RE: Ridgecrest Solar Power Project (RSPP), Docket No. 09-AFC-9, Responses to Basin and Range Watch Set 2 Data Requests #1 to #7

**RIDGECREST SOLAR POWER PROJECT (09-AFC-9)
BASIN AND RANGE NO. 2 DATA REQUESTS #1 - #7**

Technical Area: Visual (AFC Section 5.15)

Figure B&R No.2 DR-1g View from KOP-21 Residential Location on the Elevated Ridge Northeast of RSPP Site-Existing Condition

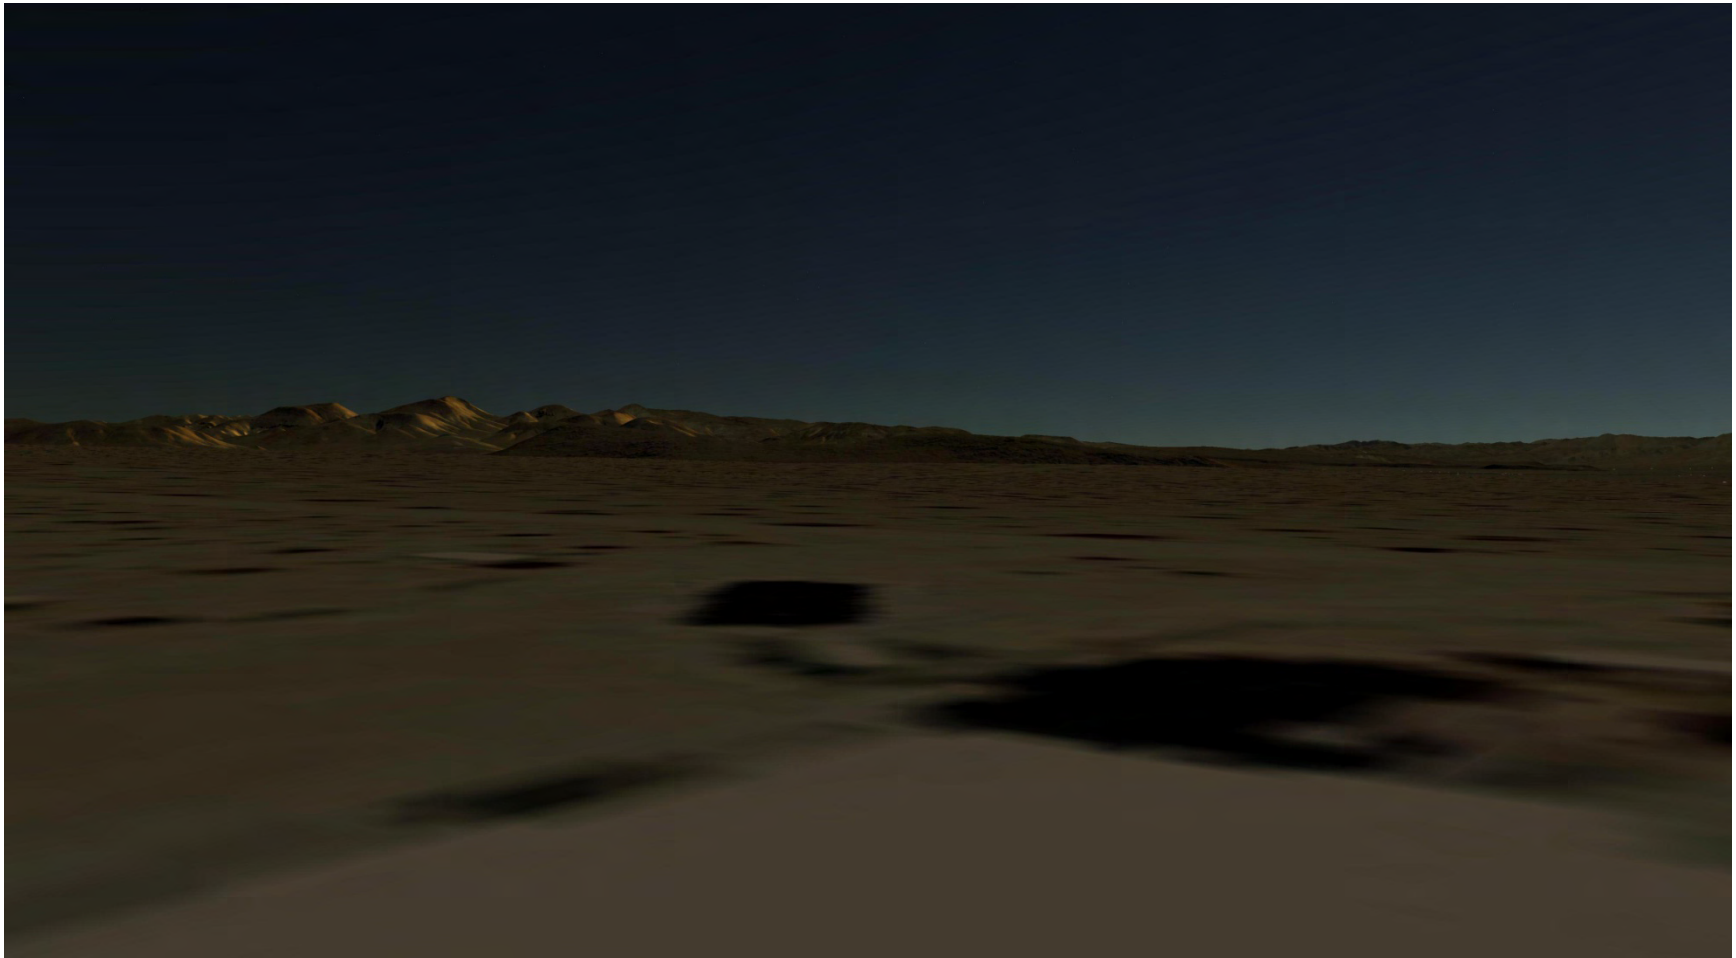
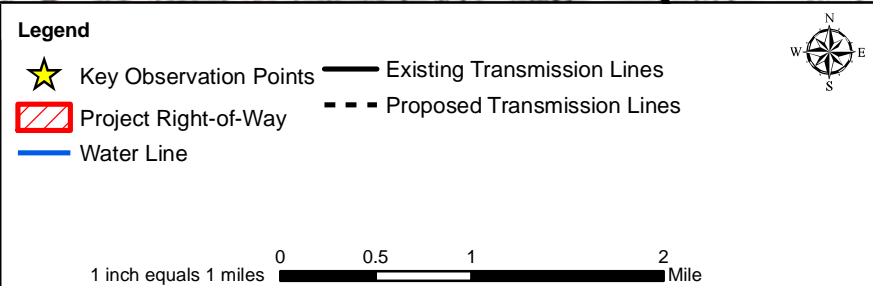
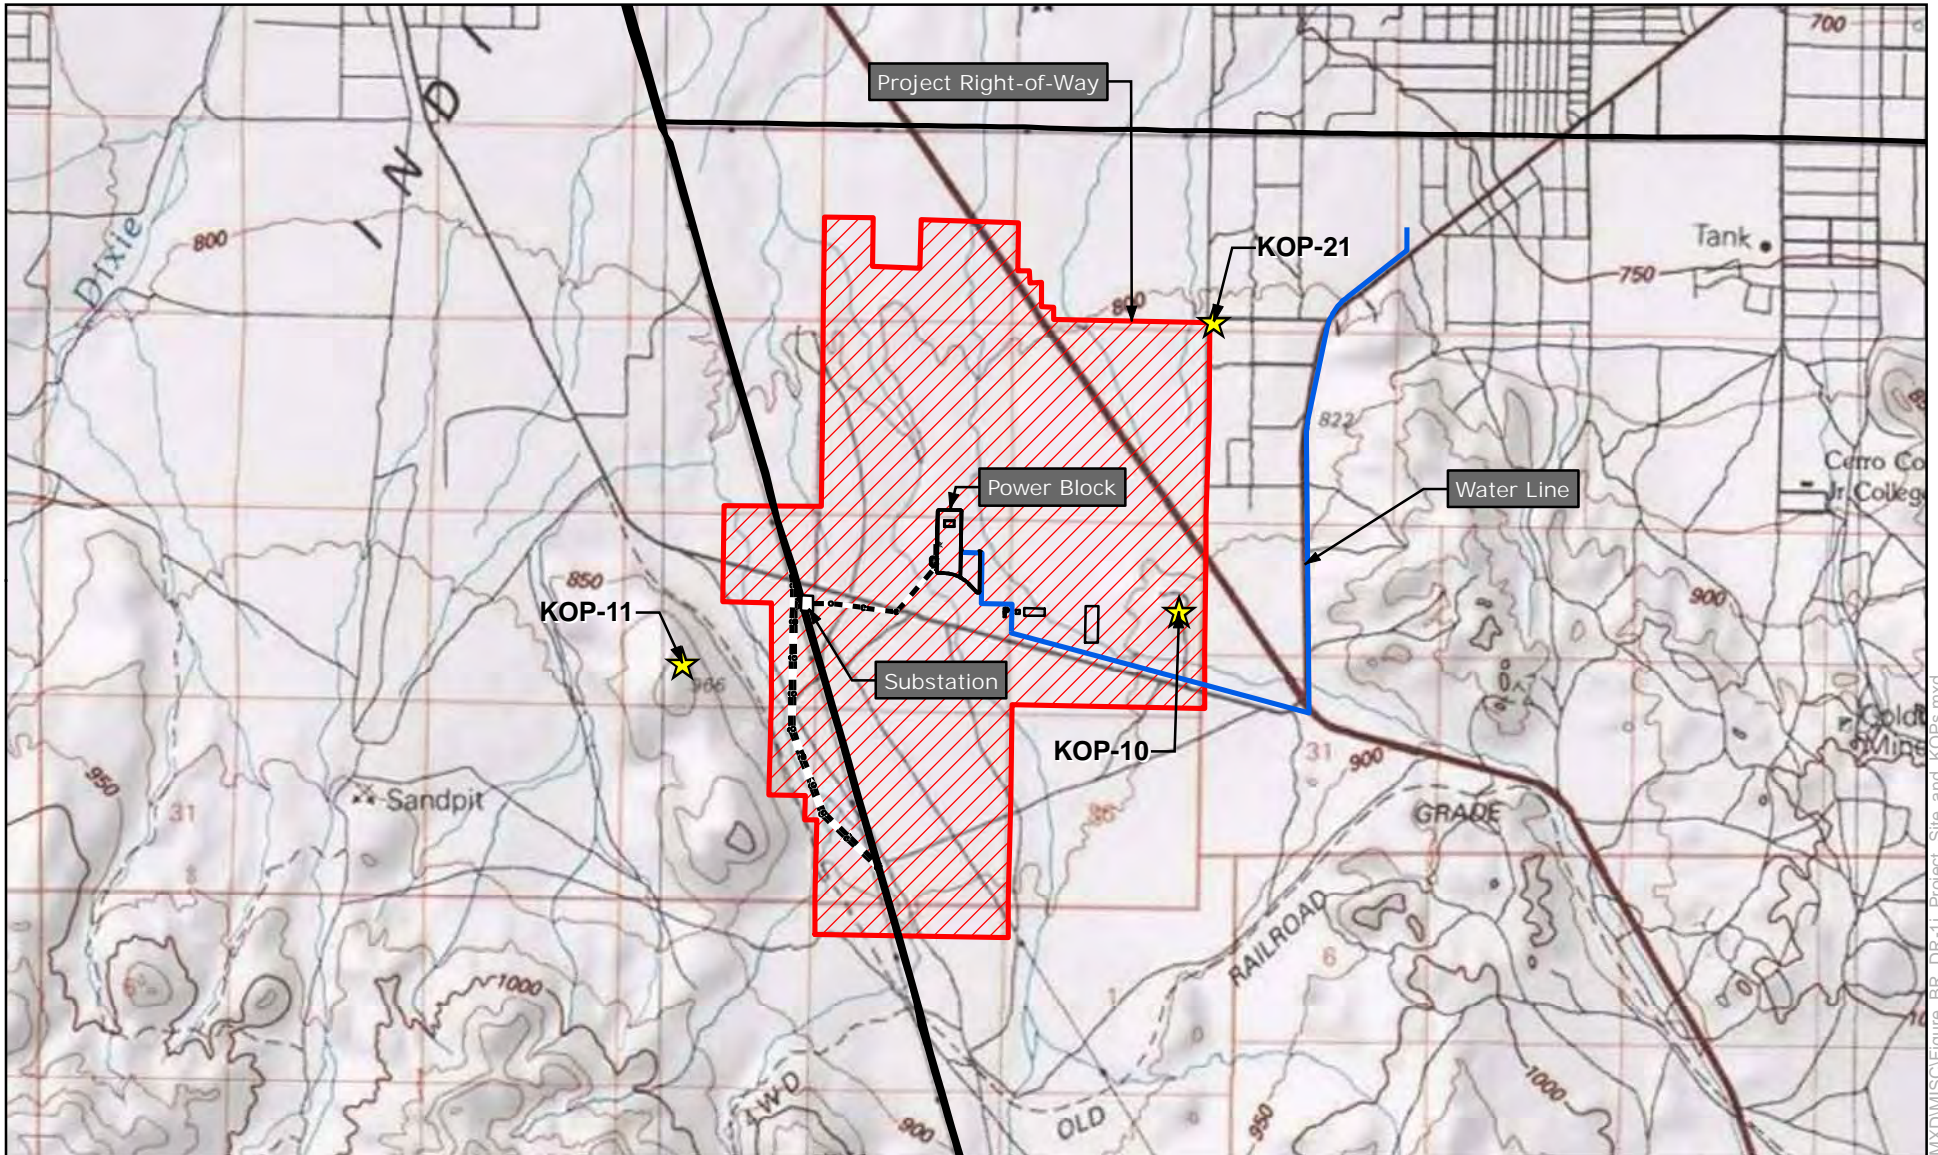
- (a) Please provide a Key Observation simulation of the night lighting from three different points.
- (b) The project site is a popular star gazing site for many individuals. Please provide an analysis of how the project will impede the activity of star gazing for astronomy groups.
- (c) Will dry cool towers be lit for aviation safety?
- (d) Would night time glare or glow from the project be visible from the community of Ridgecrest?

(a) Figures B&R No.2 DR-1a through 1i, provided at the end of this section, depict existing conditions and the night lighting of the Project facility. The three observation points selected for simulation were chosen based on their location and use. They are as follows: 1) a residential location on the elevated ridge northeast of the project site; 2) the rocky recreational site near the intersection of SR-395 and Brown Road; and 3) the elevated ridgeline on BLM land to the west of the Project site. Figure B&R No. 2 DR-1j shows the locations of the three simulation points. All three simulations demonstrate a low level of night lighting impact on viewers at these three observation points.

Figure B&R No. 2 DR-2a
Black Mountain Existing View

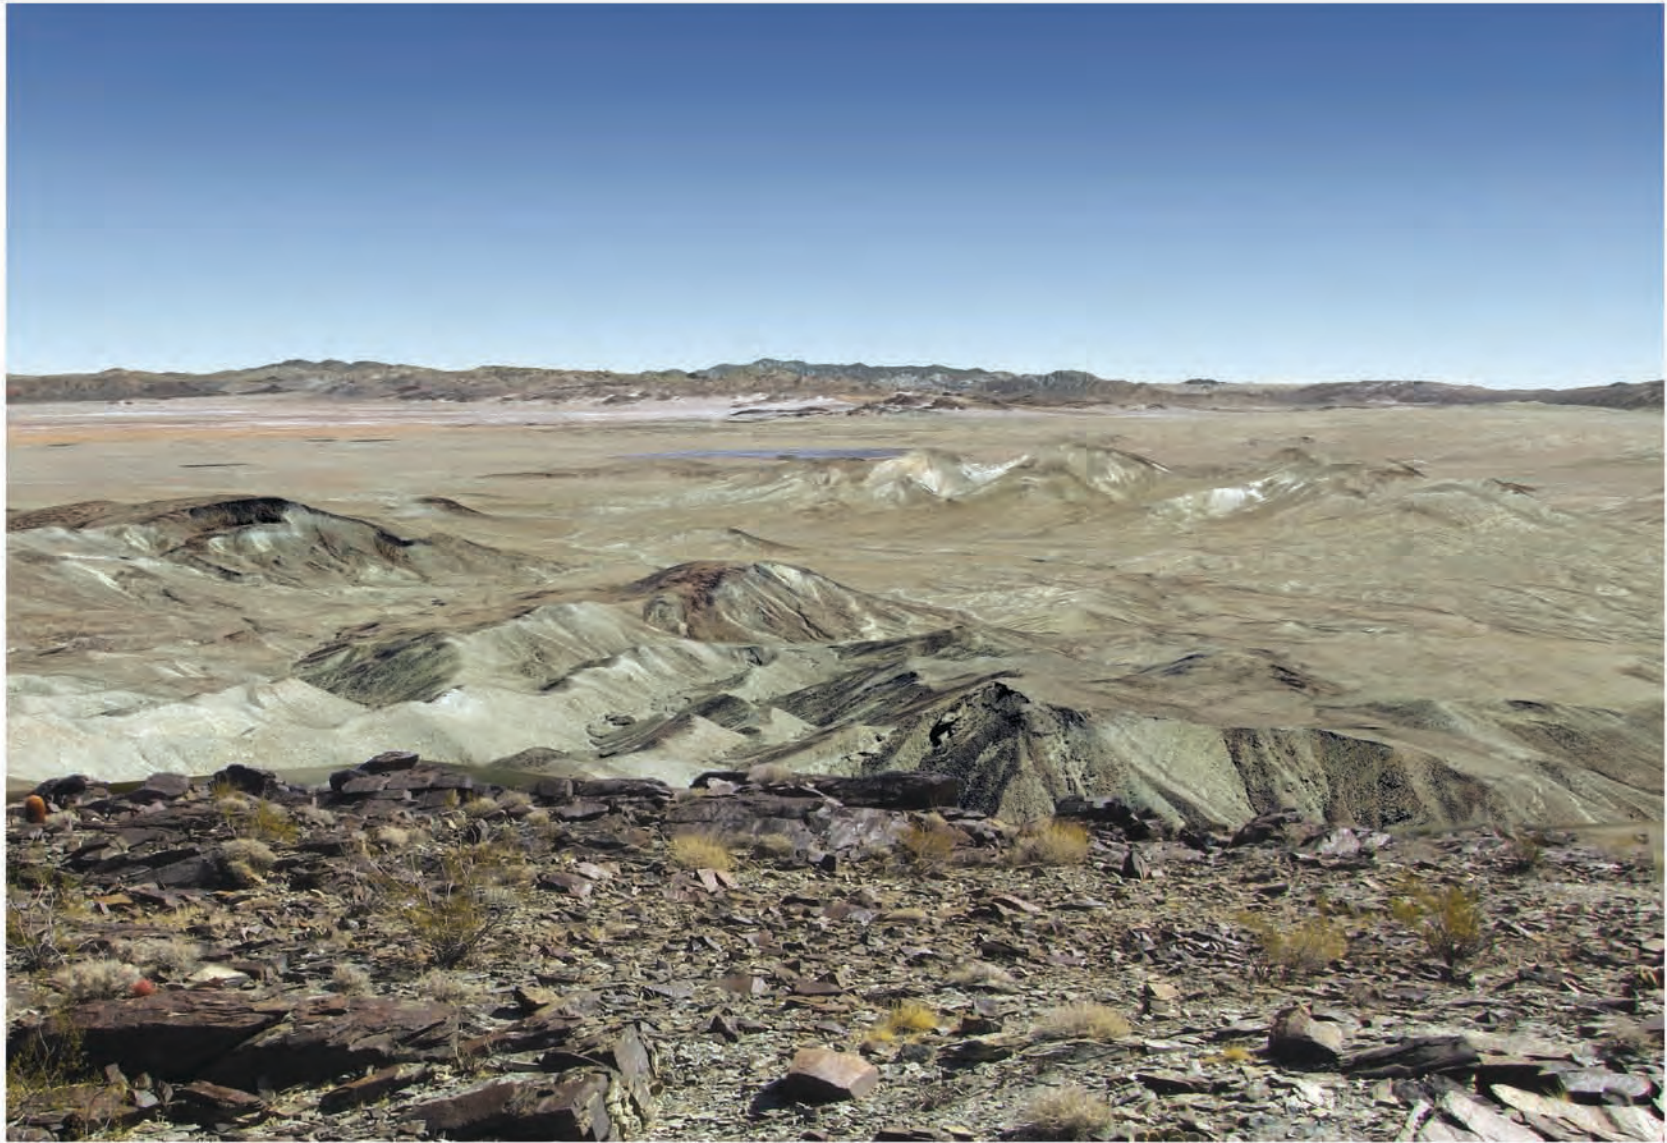
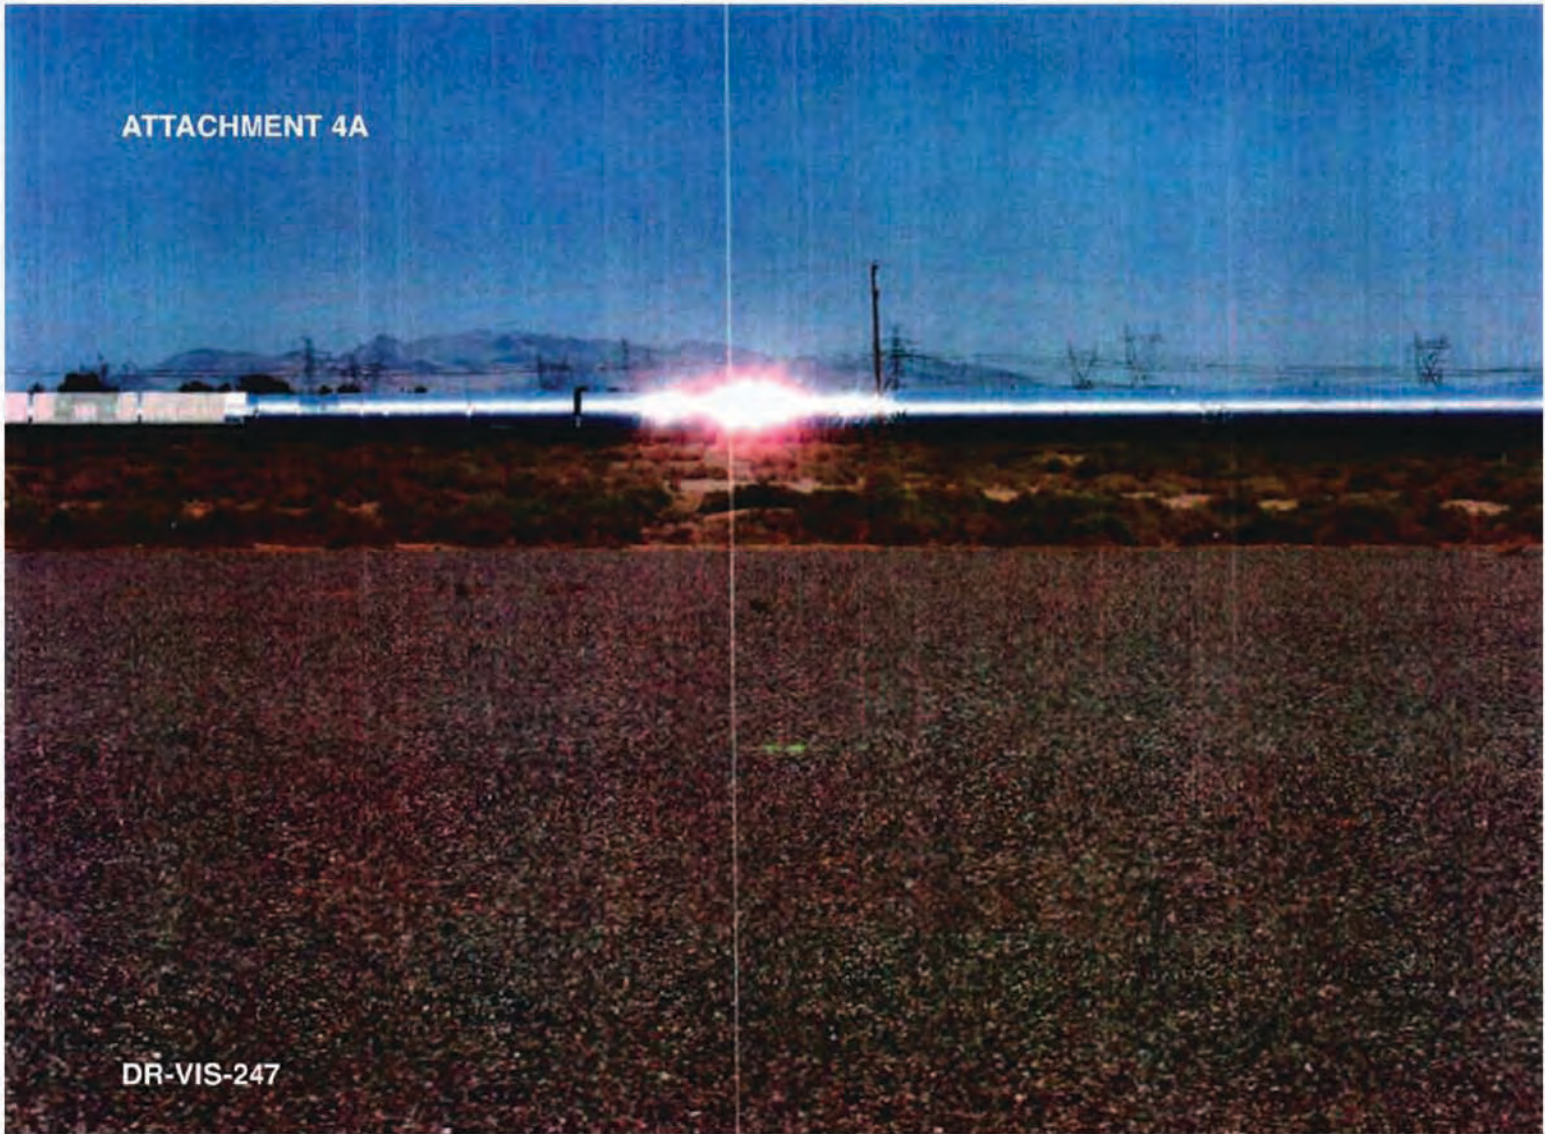
How much of the project site will be visible from the El Paso Mountains Wilderness Area? Please provide a KOP from this wilderness area.

The extent of visibility of the Project site from the El Paso Mountains Wilderness Area is calculated from the highest peak in the wilderness, Black Mountain (the KOP), as follows: 1) approximately 90-95% of the Project site north of Brown Road would be visible; and 2) approximately 2-3% of the Project site south of Brown road would be visible. This difference in visibility between the north and south portions of the Project is caused by intervening topography between Black Mountain and the Project site. The line-of-site distance from Black Mountain to the nearest edge of the project disturbance boundary is 6.3 miles. The accompany photographs (Figures B&R No.2 DR-2a and 2b) show the existing condition and visual simulation from Black, which is the highest peak in the El Paso Mountains Wilderness Area.
